DEVELOPMENT REVIEW BOARD
SUPPLEMENTAL SUBMITTAL

PROJECT NO. PR-2021-006070

Re: Westpointe40 North Site Plan DRB Comment Responses (PR-2021-006070)

This memo outlines the responses and changes made to the site plan for the proposed 150K spec industrial building at Westpointe40 based on the comments received and reviewed at the December 15, 2021 DRB meeting.

TITAN 150K SPEC BUILDING ALBUQUERQUE, NM	DRAWN BY pm
	SITE PLAN FOR BUILDING PERMIT	DATE 12-22-21
	TIERRA WEST, LLC 5571 MIDWAY PARK PL NE ALBUQUERQUE, NEW MEXICO 87109 (505) 858-3100 www.tierrawestllc.com	DRAWING 2020088-150K.DWG
		SHEET # SP-1
RONALD R. BOHANNAN P.E. #7868		JOB # 2020088

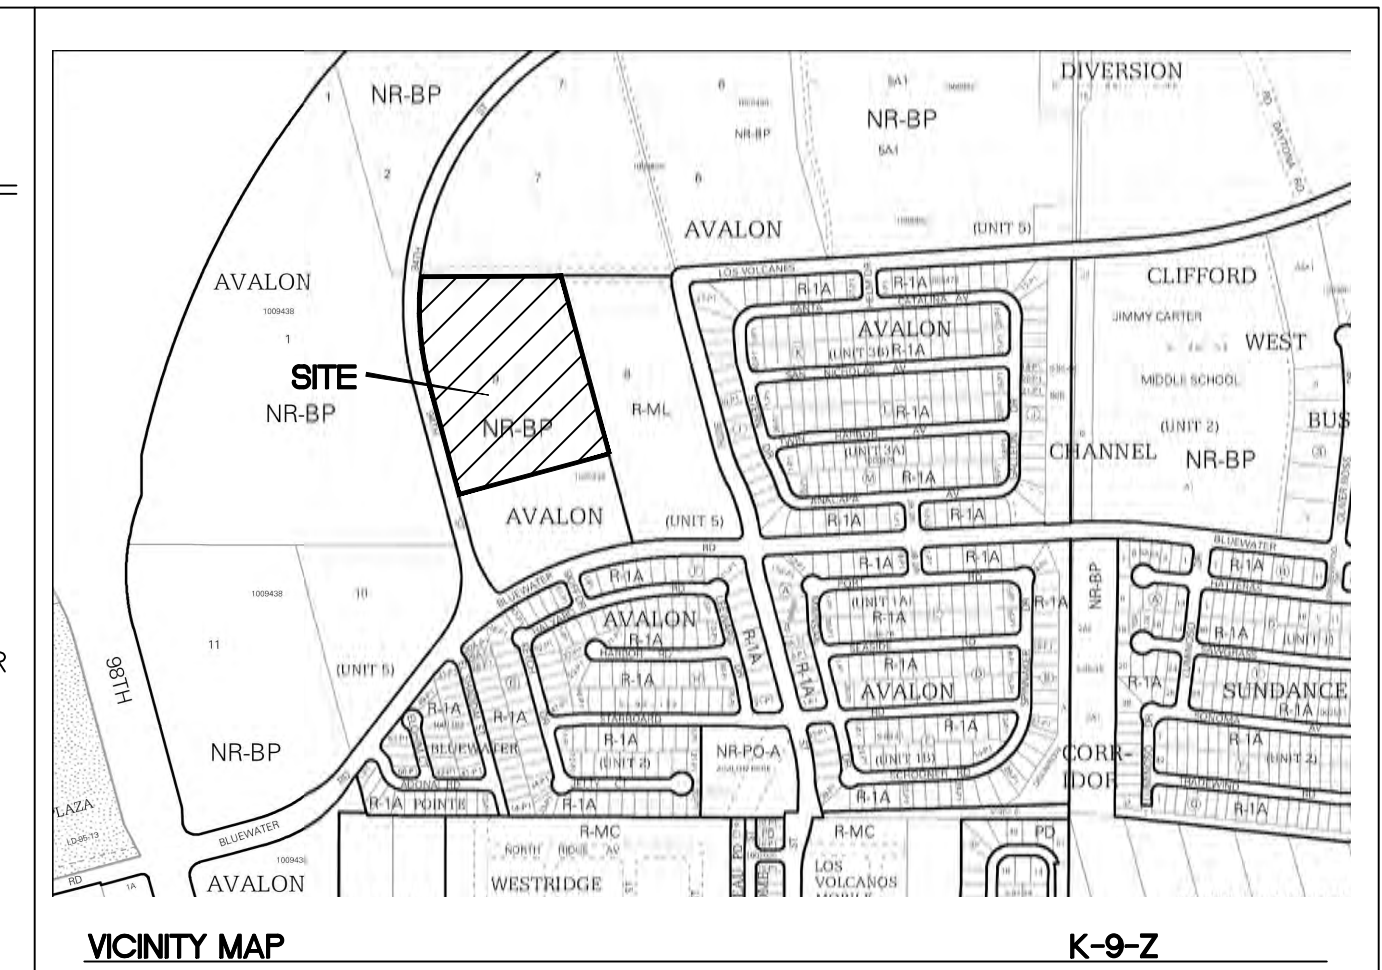
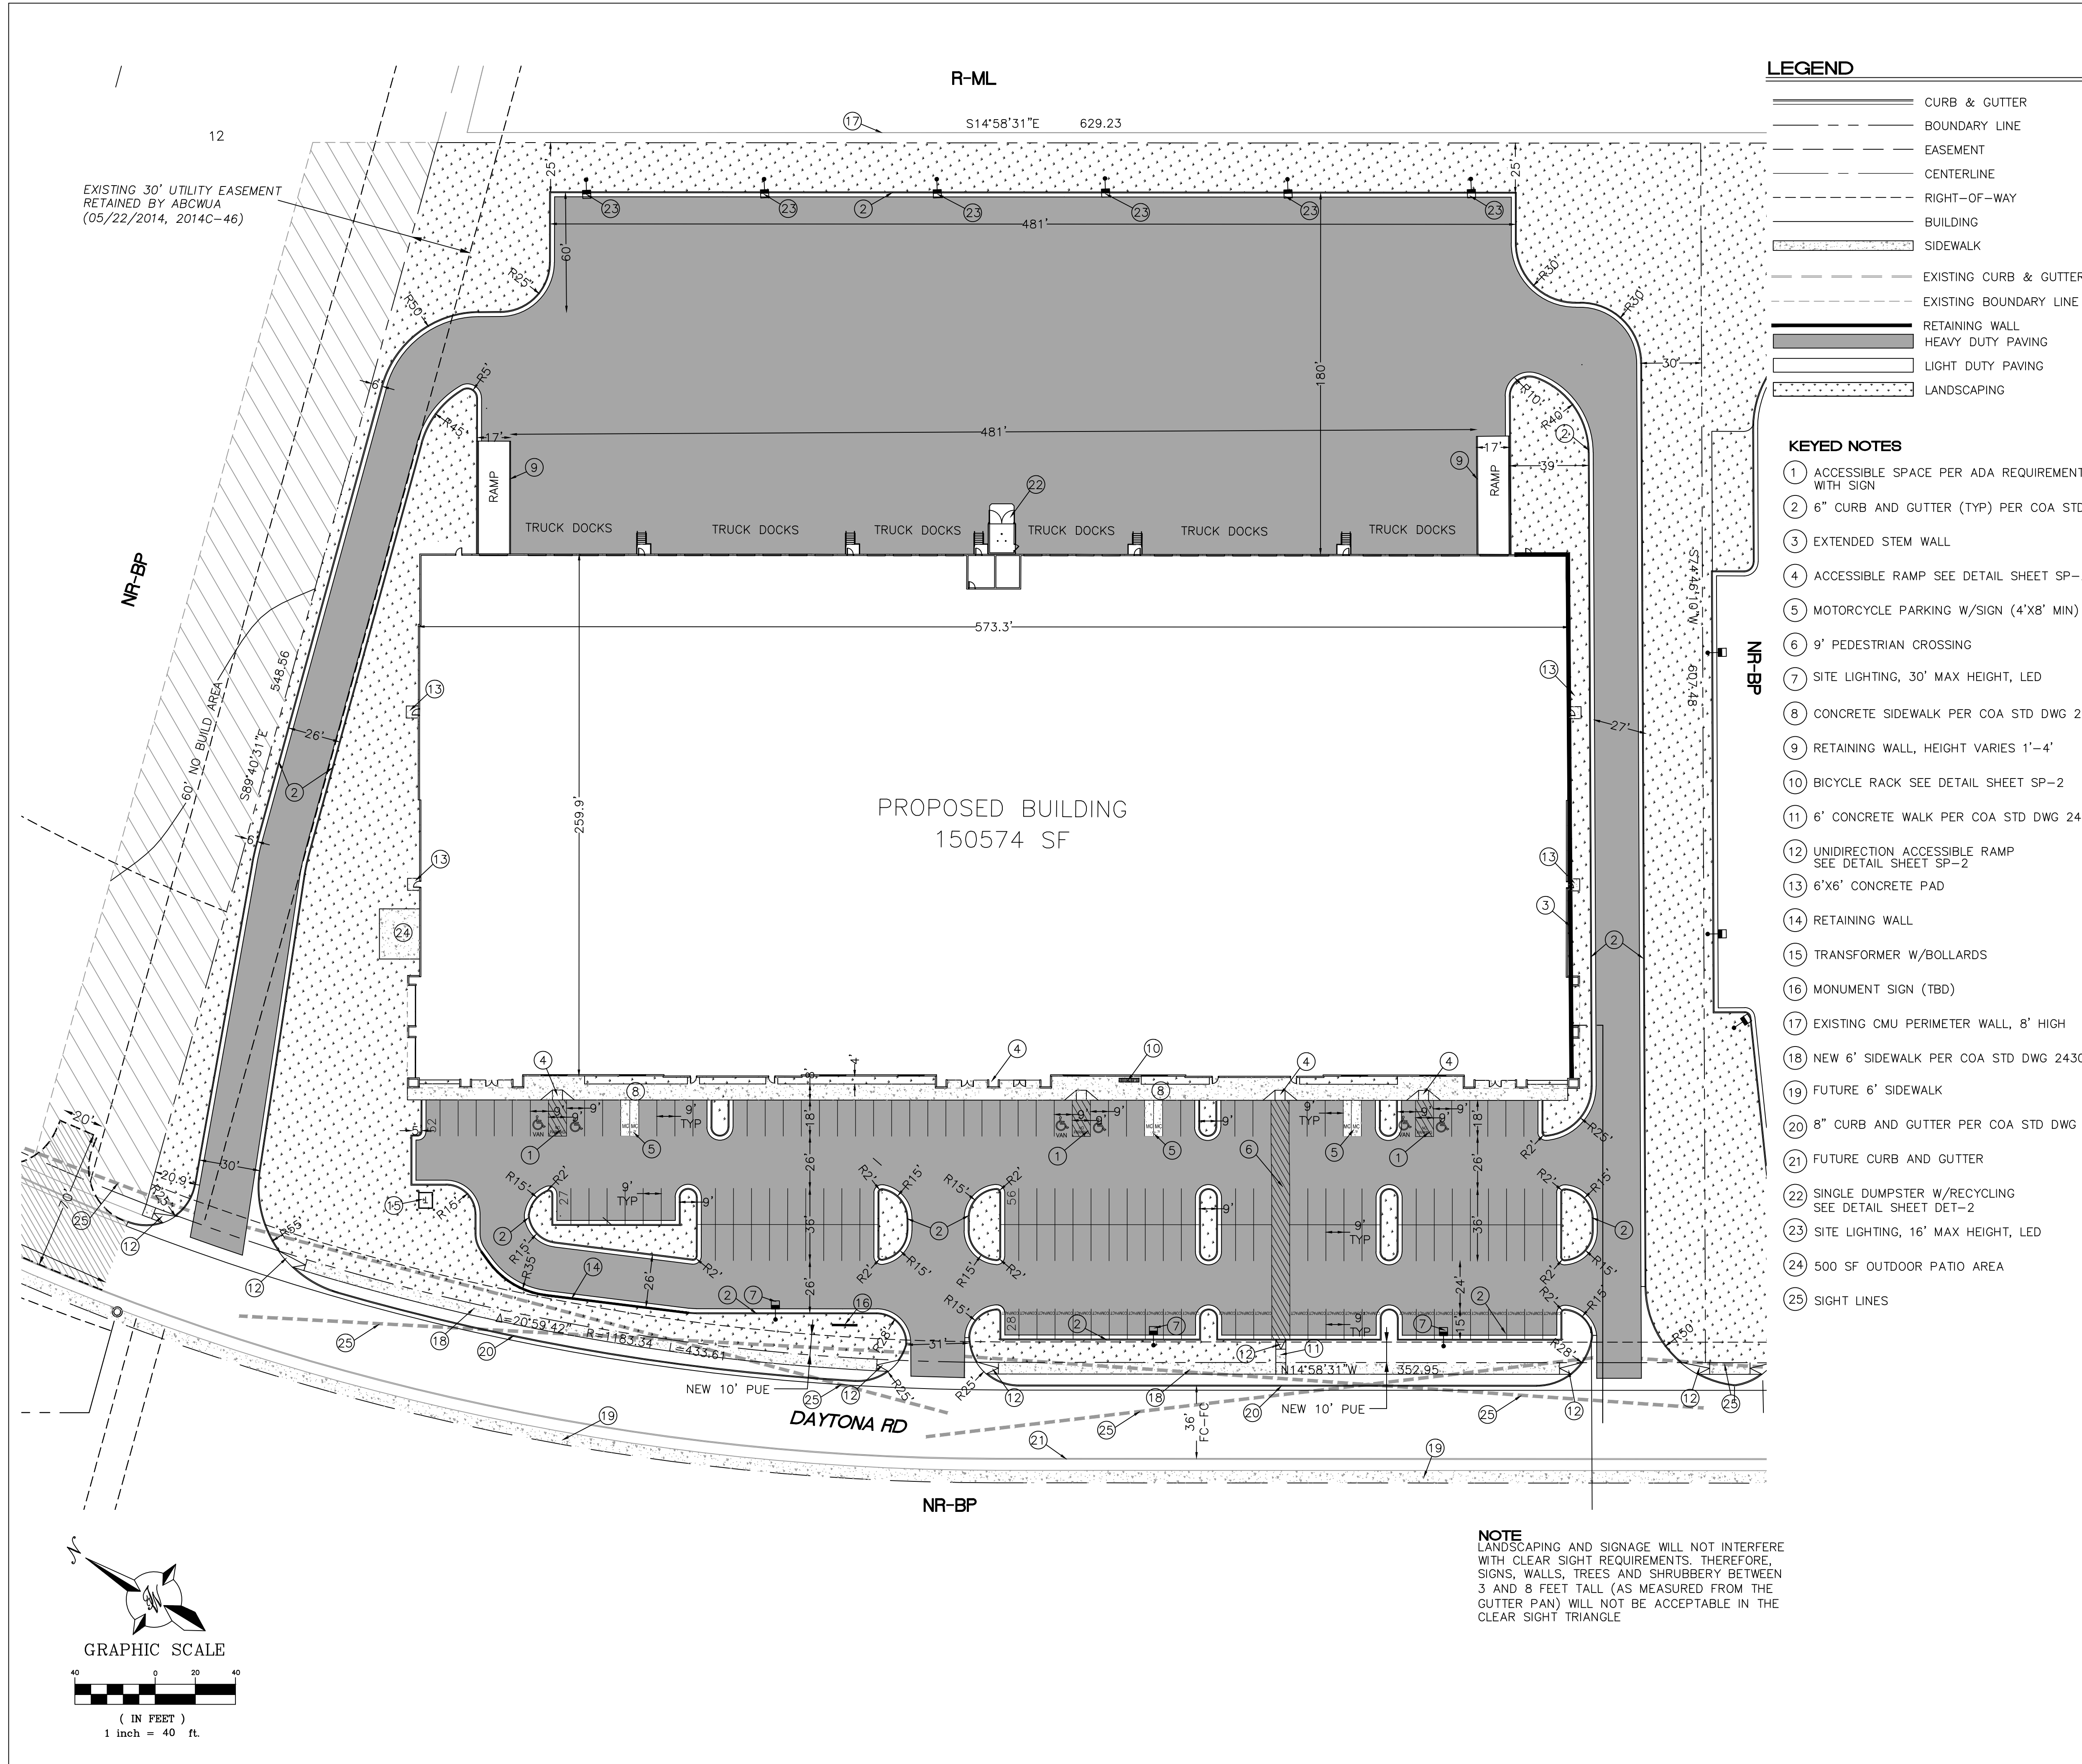
3. Provide an exhibit which shows how the turn-around on Daytona will function and reflect this in on the infrastructure list more accurately.
 - *The temporary turnaround has been added to the Site Plan and an exhibit is also provided. The infrastructure list has been updated accordingly.*
